SUBSURFACE WASTEWATER DISPOSAL SYSTEM APPLICATION

AUGUSTA PERMIT # 354 TOWN COPY

Town Or Plantation	Augusta
Street Division Lot #	Riverside Drive

SUBSURFACE WASTEWATER DISPOSAL PLAN

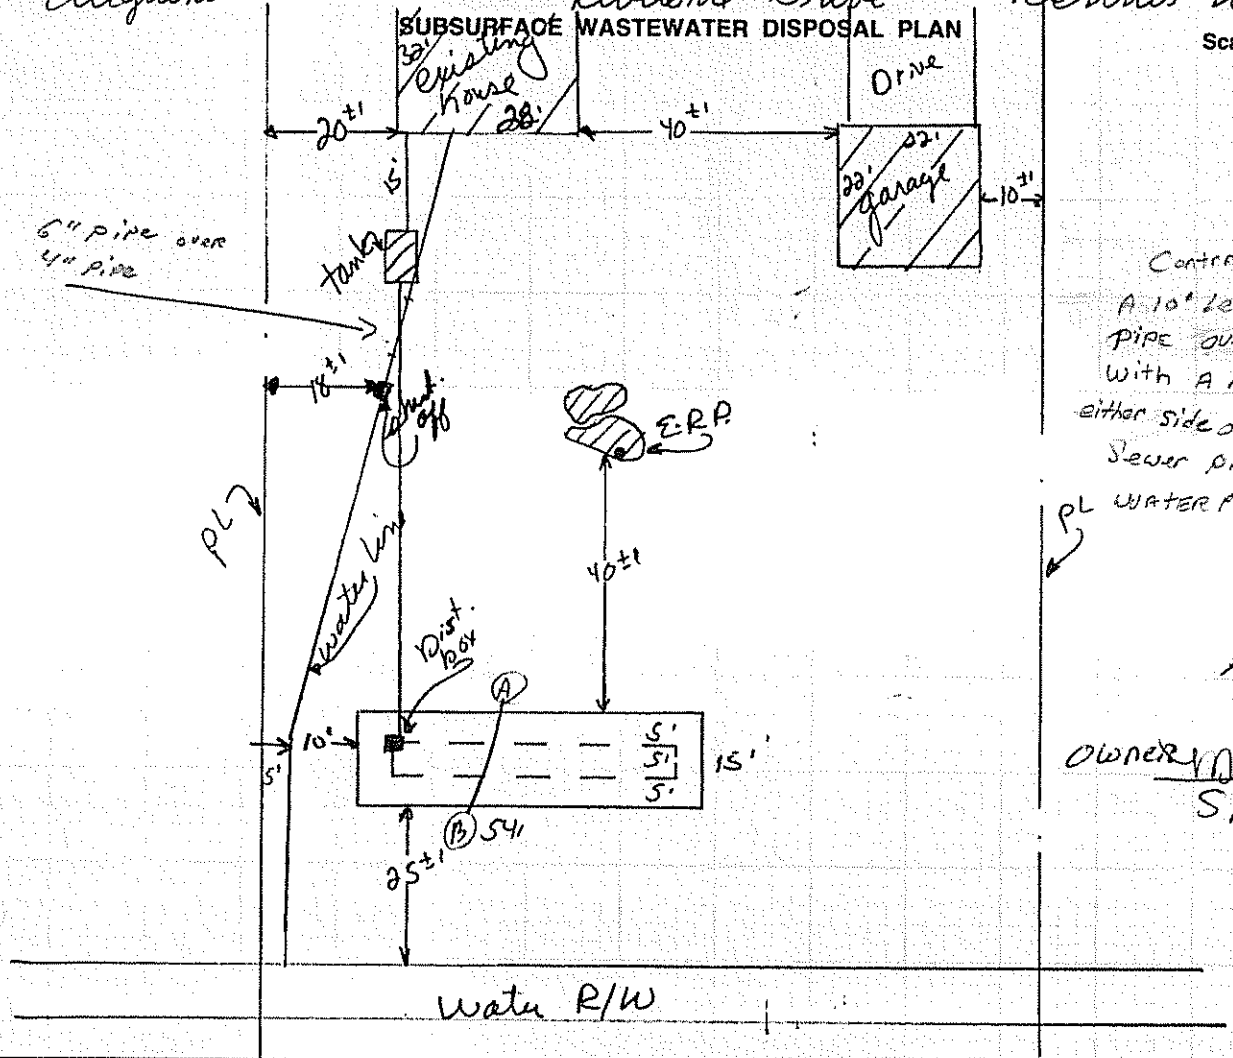
Contractor shall install a 10' length of 6" #40 pipe over 4" sewer pipe with a no hub fitting on either side of pipe where the sewer pipe crosses the water pipe.
